CITY OF ALBUQUERQUE

**Re: Montezuma Elementary School
3100 Indian School Rd. NE
Request Permanent C.O. - Accepted
Engineer's Stamp dated: 4-8-14 (G13D023B)
Certification dated: 10-10-14**

MONTESUMA ELEMENTARY SCHOOL
3100 INDIAN SCHOOL NE, ALBUQUERQUE, NM 87106
GRADING & DRAINAGE PLAN, AND
POST DEVELOPMENT BASIN PLAN
TURF PLAY FIELD ADDITION

**RE: Montezuma Elementary Play Field
Grading and Drainage Plan
Engineers Stamp Date 4/18/14 (J16D009)**

C-101

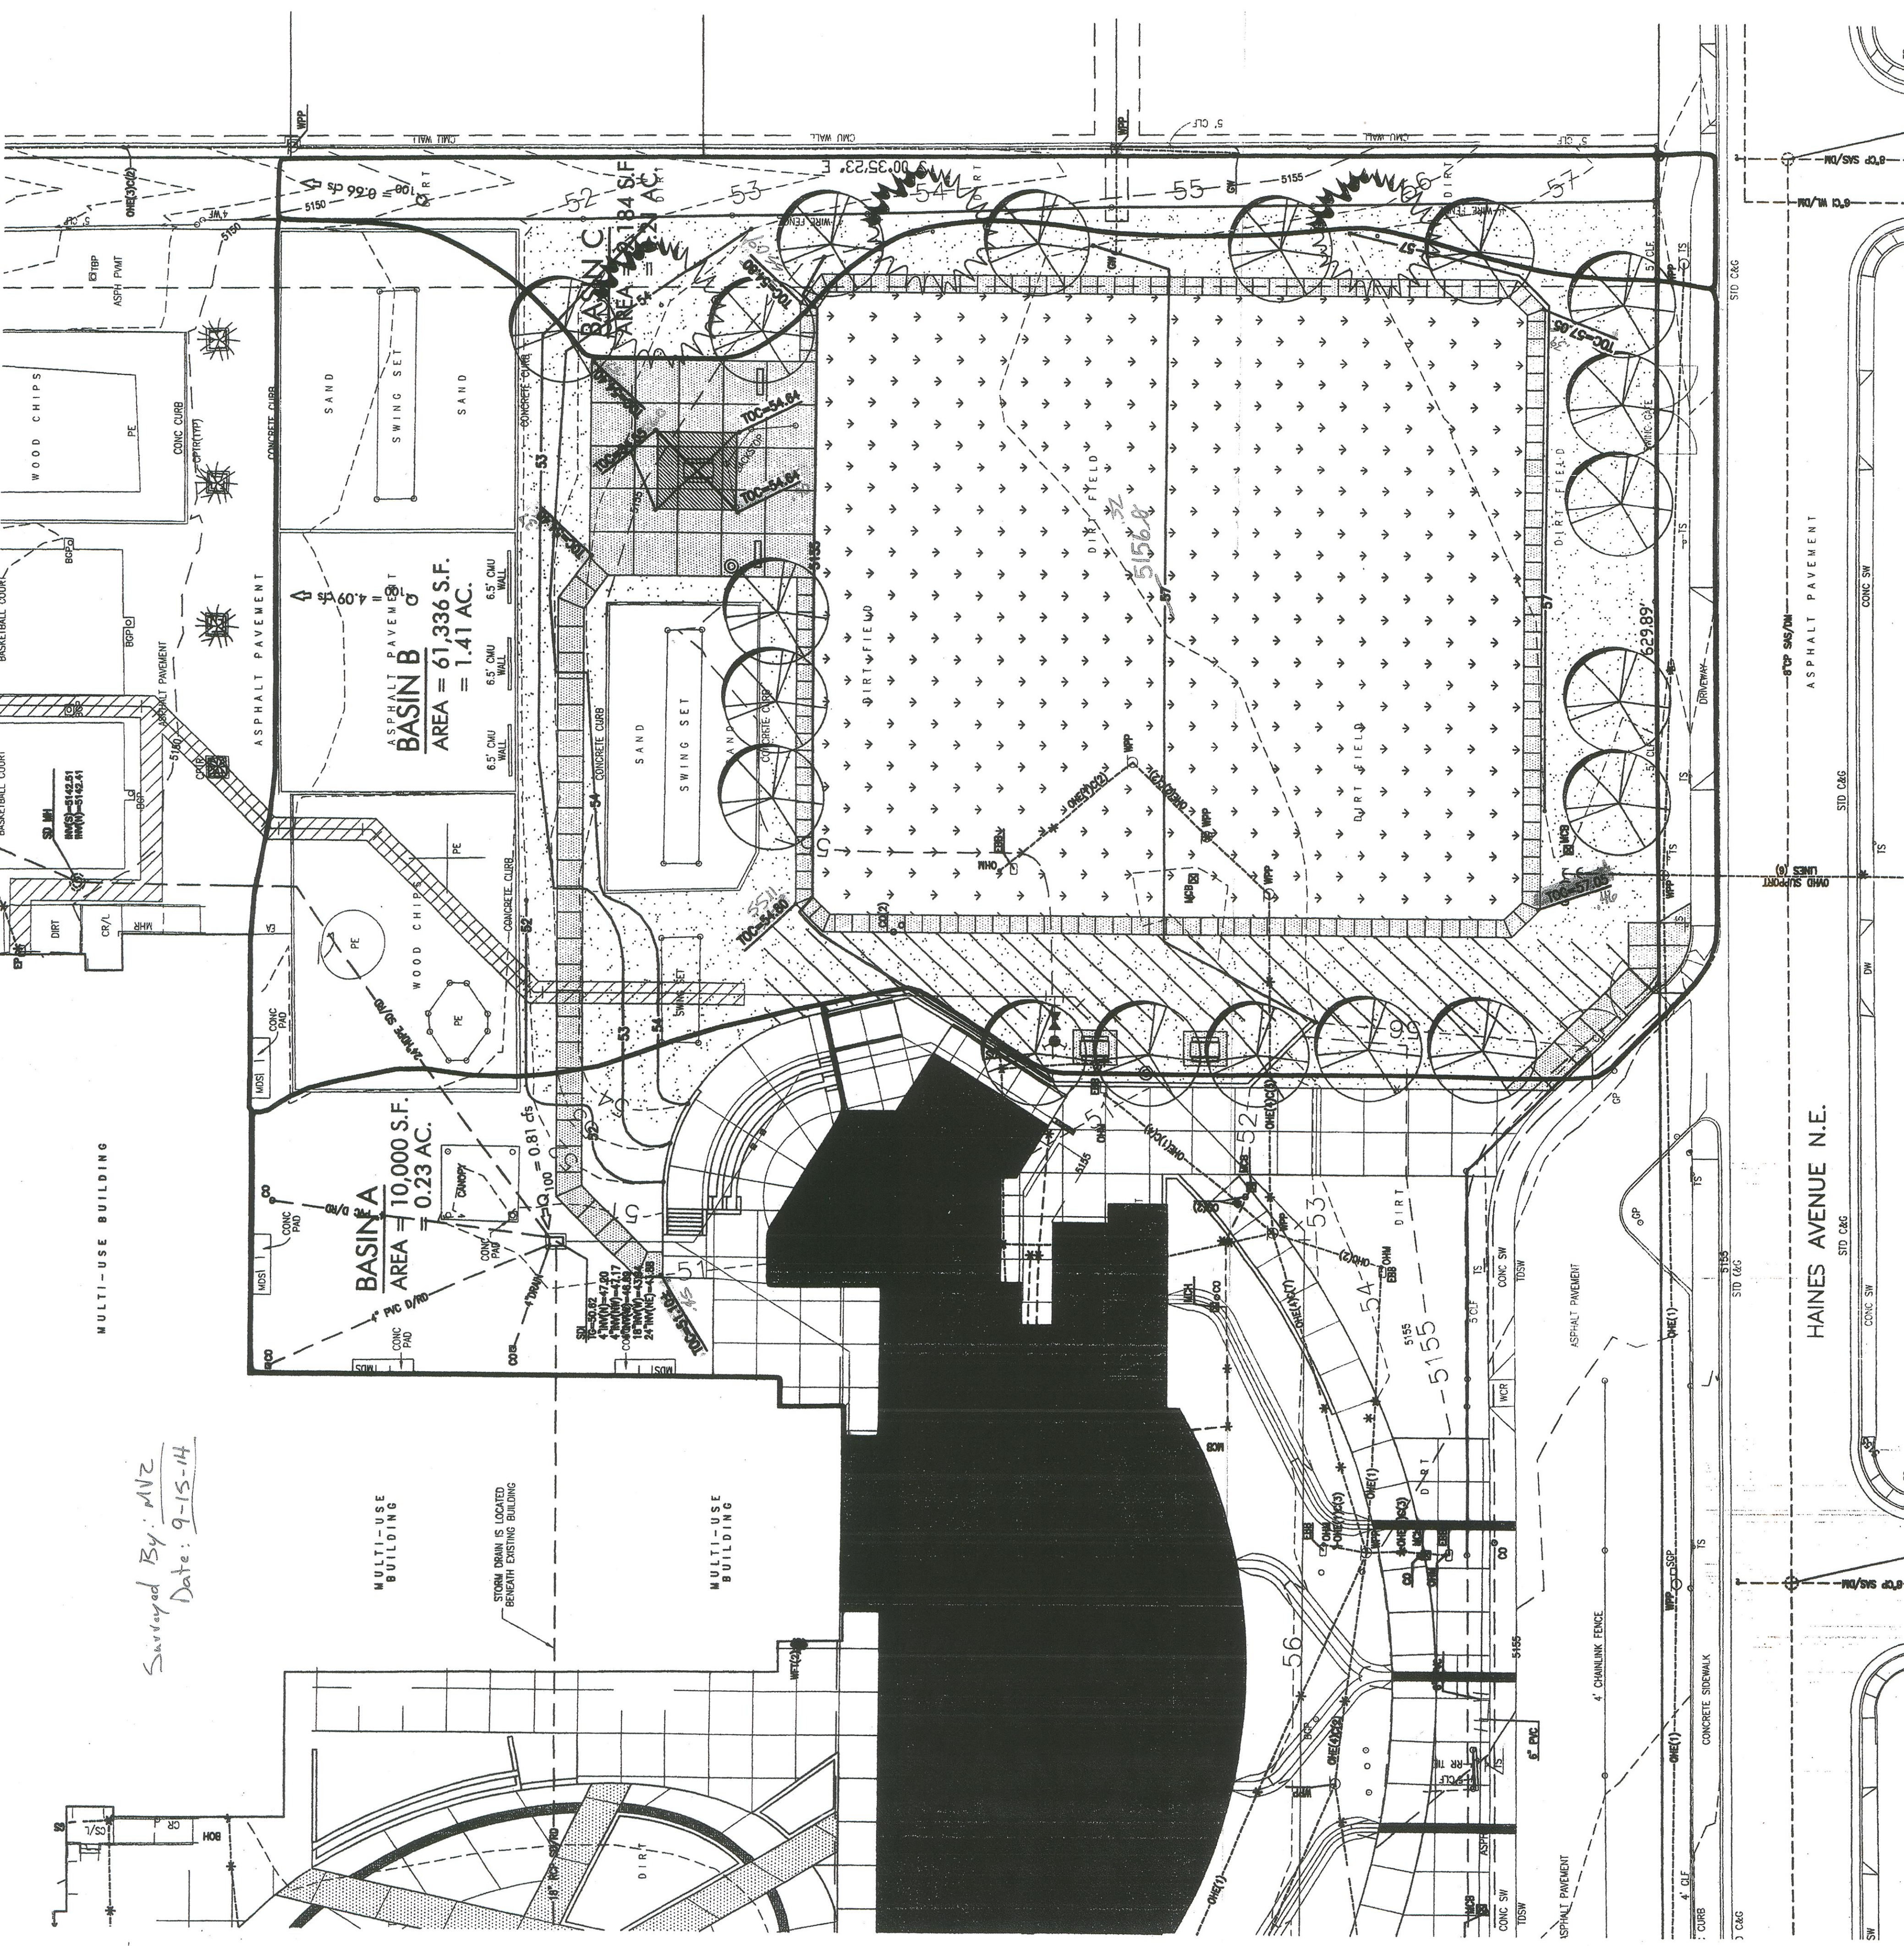
Based upon the information provided in your submittal received 4/21/14, the above referenced Grading and Drainage Plan (G&D) is acceptable for Building Permit and Paving Permit. Hydrology is requesting that proposed landscape areas be depressed to retain/infiltrate the rain that falls on them and if possible have existing flows, flow through the landscape areas for water harvesting and water quality.

This project requires a National Pollutant Discharge Elimination System (NPDES) permit for storm water discharge and a Topsoil Disturbance Permit since it is disturbing $\frac{3}{4}$ of an acre or more.

Before building permit approval, an Erosion and Sediment Control Plan (ESC) must be submitted and accepted. Attach a copy of the ESC plan and this approved G&D plan to each of the Building Permit sets prior to seeking approval by the Hydrology section.
